STATE OF NEW YORK  
PUBLIC SERVICE COMMISSION

**In the Matter of a Review of the Long-Term Gas System Plans of Consolidated Edison Company of  
New York, Inc. and Orange and Rockland Utilities, Inc.**

**Case 23-G-0147**

Initial Comments of  
Natural Resources Defense Council,  
with assistance from Synapse Energy Economics

Figure 1. Hybrid Pathway: System Volumes and Composition

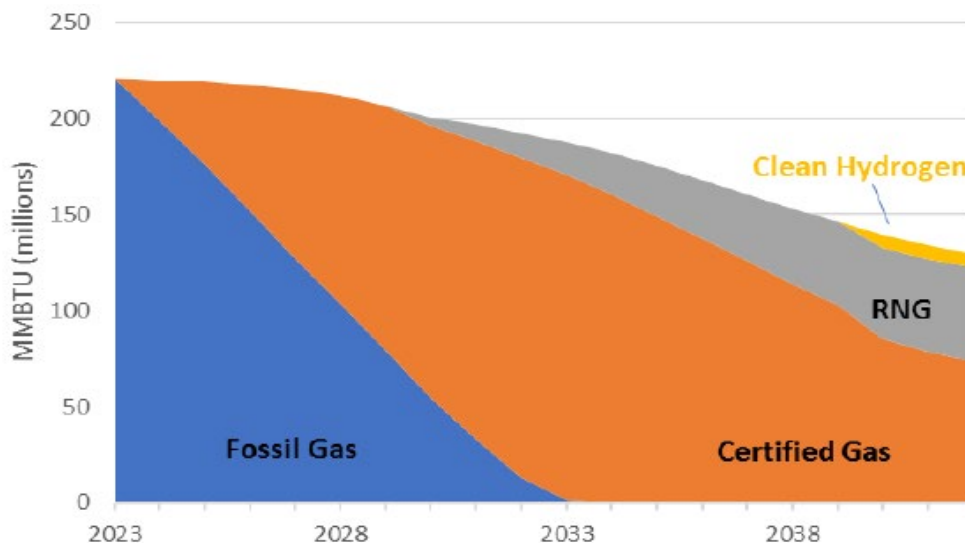
For the Hybrid pathway, the Companies project a moderate reduction in gas volumes (39 percent) and emissions (61 percent) by 2042. As shown in Figure 1, this scenario includes large quantities of RNG (37 percent) and certified fossil gas (57 percent), with lesser quantities of hydrogen (6 percent) in 2042.<sup>16</sup>

Figure 2. Deep Electrification Pathway: System Volumes and Composition

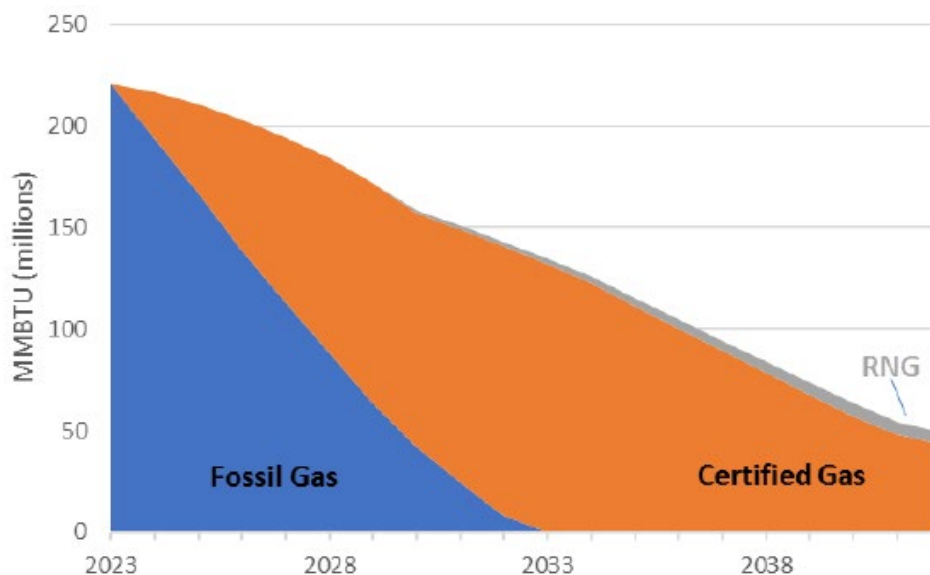
The Deep Electrification pathway projects a steeper reduction in gas volumes (76 percent) and in emissions (82 percent) by 2042. In that pathway, gas volume projections for 2042 (49 TBTU) include a smaller share of RNG (13 percent), but still large amounts of certified fossil gas (87 percent).<sup>17</sup> See Figure 2.
